HORSHAM DISTRICT COUNCIL CONSULTATION

TO:	Horsham District Council – Planning Dept
LOCATION:	Land at Station Road Warnham
DESCRIPTION:	Outline application for the erection of approximately 24 residential dwellings, with all matters reserved except for access.
REFERENCE:	DC/26/0585
RECOMMENDATION:	Advice / modification
2nd response in Red	Advice / more info
3rd response in green	Advice / More Info
SUMMARY OF COMMENTS & RECOMMENDATION: The application is supported by an Arboricultural Constraints Survey, Impact Assessment, Protection Plan, and Method Statement prepared by Ecosurv Ecological Consultancies. The application site contains a mix of individual trees, groups, and woodland edge vegetation typical of a semi-rural setting. The Arboricultural Report has been undertaken broadly in accordance with BS 5837:2012 and identifies eleven individual trees, seven groups, and one hedgerow. The Arboricultural Report advises that the majority of trees within the central parts of the site are proposed for removal to facilitate development, with only a limited number retained, primarily around the periphery of the area of the proposed development. There are also instances where the site layo

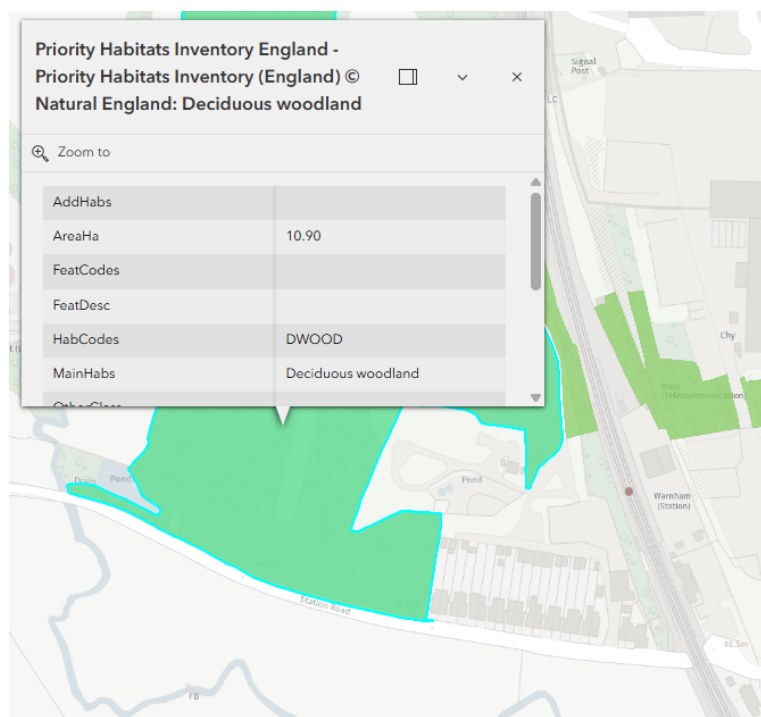
As raised previously, no overriding justification has been provided to demonstrate that RPA encroachment is unavoidable or has been minimised as far as possible. As such, whilst the proposed mitigation measures may reduce potential impacts, it is not considered that sufficient evidence has been provided to demonstrate that the proposals are fully aligned with the core principles of BS 5837. Any development within the RPAs of retained trees should be supported by robust justification demonstrating that avoidance has been fully considered.

Consideration should therefore be given to relocating Units 12 and 13/14 further south to establish a more appropriate tree-to-building relationship with the Oak T8, as the current layout not only results in development in the RPA of T8, it also doesn't account for any working space during the build out stages to allow for the units in question without further compromising the RPA.
